Re: Product Change Notification for Harwin packaging.

Please be advised that the pick and place cap used on male Datamate connectors (M80 Series) has been changed from a metal stamped cap to a plastic cap. This has been identified and implemented as part of our continuous improvement program at Harwin. The visual difference is as follows:

Left = New plastic cap, Right = Previous metal cap

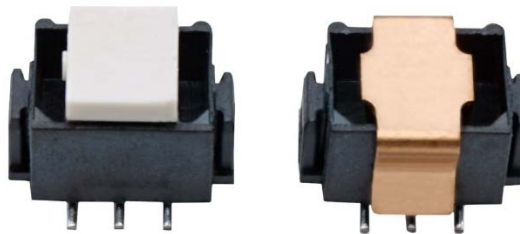
As you can see from the profile of the plastic cap, a small amount of additional height has been introduced, and changes to the settings on your pick and place machines may be required. Please also note, we use a selection of materials for the plastic cap which will result in either natural or black plastic, depending on availability.

The connector design itself is unchanged. Please note that we are no longer able to supply the metal cap once stock of the existing packaging is exhausted.
